N9048B-02

Modification Recommended Service Note

N9048B PXE EMI Receiver

Serial Numbers: MY59500006, MY59500012, MY59500015, MY59500016, MY59500020, MY59500021, MY60450107

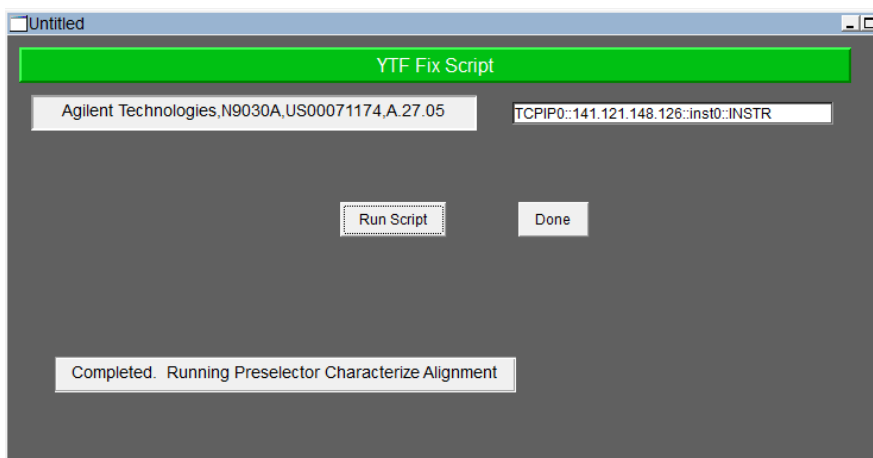
A utility is available if you have a PC that can remotely control the signal analyzer via LAN, GPIB, or USB, and you can install the VEE run time engine on the PC. The utility will modify the calibration values on the analyzer's disk image and trigger the Characterize Preselector routine.

Download the utility from http://sa.support.keysight.com/XSA/YTF_util/YTF_Fix.vxe

Carefully enter the instrument's VISA address into the upper right box and click Run Script.

For example, if an instrument is connected to a common LAN router with an external PC, then the VISA address would be in the format of: TCPIP0::192.168.0.2::inst0::INSTR, where 192.168.0.2 is the instrument's IP address.

The utility will complete the changes to the instrument's disk image and then perform the Characterize Preselector routine that takes a few minutes.
